Sierra Club Loma Prieta Chapter
Serving San Mateo, Santa Clara and San Benito Counties
Protecting Our Planet Since 1933

June 6, 2017

RE: Sierra Club comments opposing Lehigh Southwest Cement's request to move the treated water discharge location on Permanente Creek, NPDES Permit Order No. R2-2014-0010.

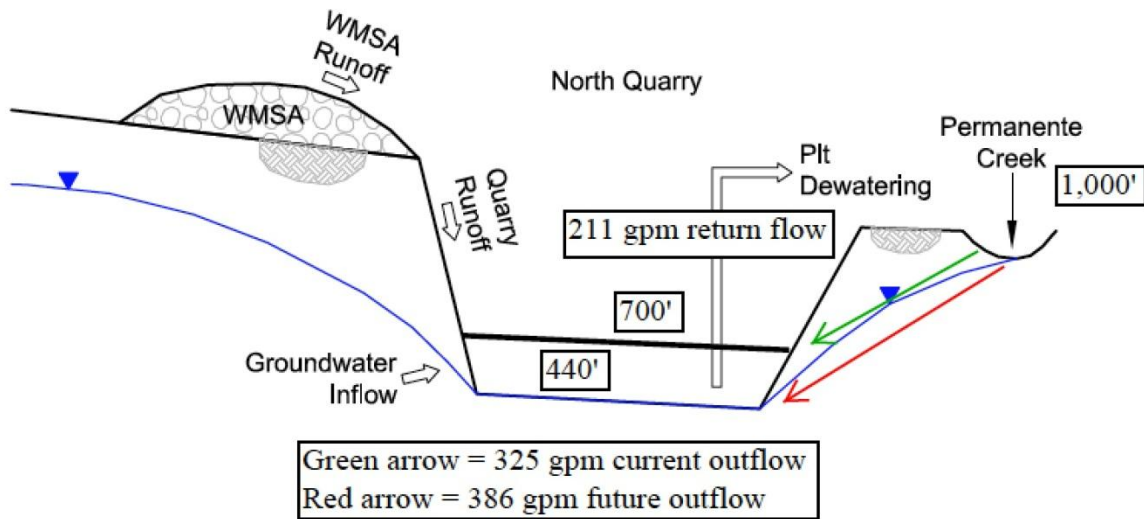
Lehigh's request should be rejected; Lehigh's current Pond 4A discharge point should be retained. That point, shown in relationship to the Lehigh quarry, is shown below.

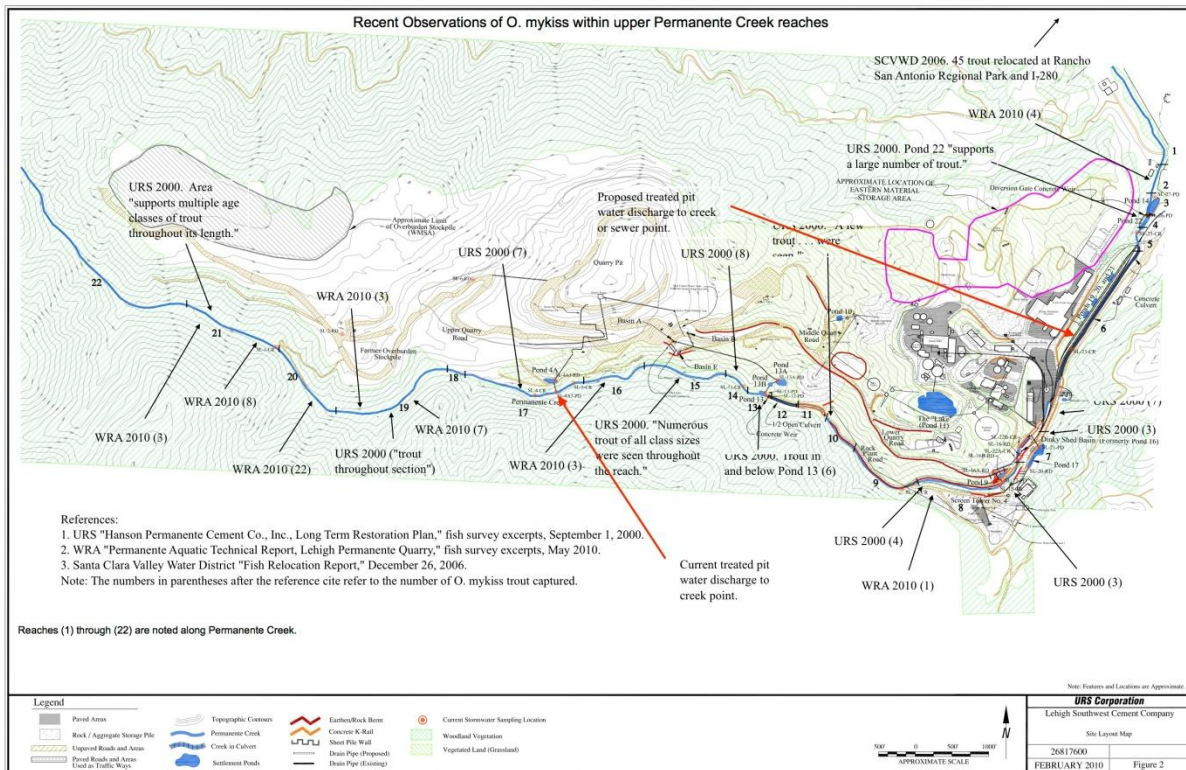
To what extent would Permanente Creek be deprived of FTS treated water return flows if Lehigh's request to change the point of discharge from Pond 4A to the cement plant location? The map below indicates at least a mile of creek would be adversely affected. Not only would resident fish be harmed by this significant reduction in flow between Pond 4A and the cement plant, but all related species and riparian habitats.
